Date of Meeting	15 th June 2017
Application Number	17/02061/FUL
Site Address	Hillside House, Lockeridge, Marlborough, Wiltshire SN8 4EL
Proposal	Erection of a replacement side extension, glazed link into associated outbuilding and new attached store, internal and external alterations to main house and outbuilding, associated hard and soft landscaping.
Applicant	Mr Mark Lawson
Town/Parish Council	FYFIELD WEST OVERTON
Ward	West Selkley ED (Cllr Jane Davies)
Grid Ref	414836 167897
Type of application	Full Planning Permission
Case Officer	Lucy Rutter

1. Purpose of Report

To consider the recommendation that the application be refused planning permission.

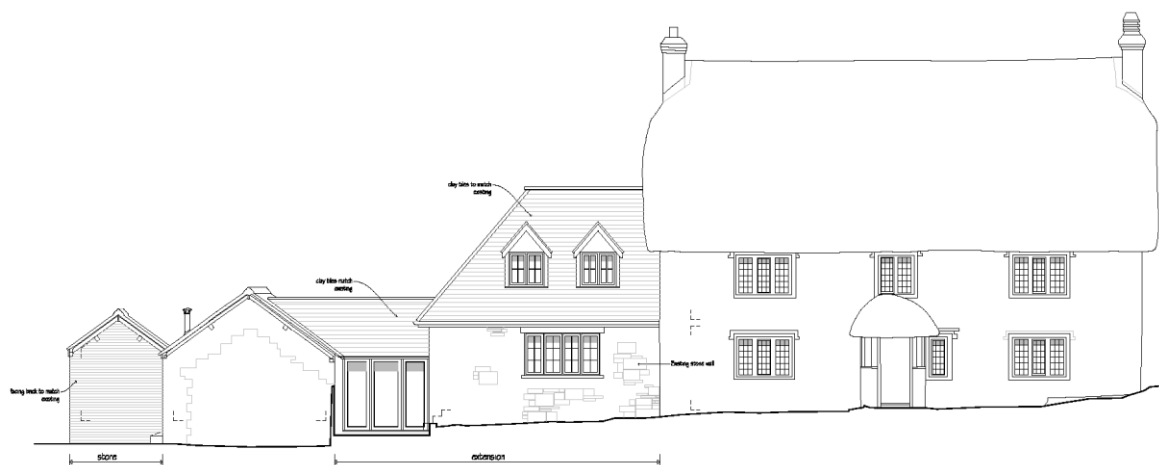
The ridge line of the proposed side extension sits well below that of the original thatched dwelling, which is of benefit when viewed from the principal elevation as the extension appears as a subservient addition. However, the projection to the rear of the property, together with the proposed link extension, would result in extensions with a larger footprint than that of the original dwelling which would be overly dominant and would not respect the plan form of the original dwelling. The rear projecting gable feature also seems overly dominant in terms of mass and bulk and would therefore appear as an incongruous addition to the northern elevation of the property.

The design of the extensions is commented on in more detail below. There are no concerns regarding the garden store extension from a planning perspective.
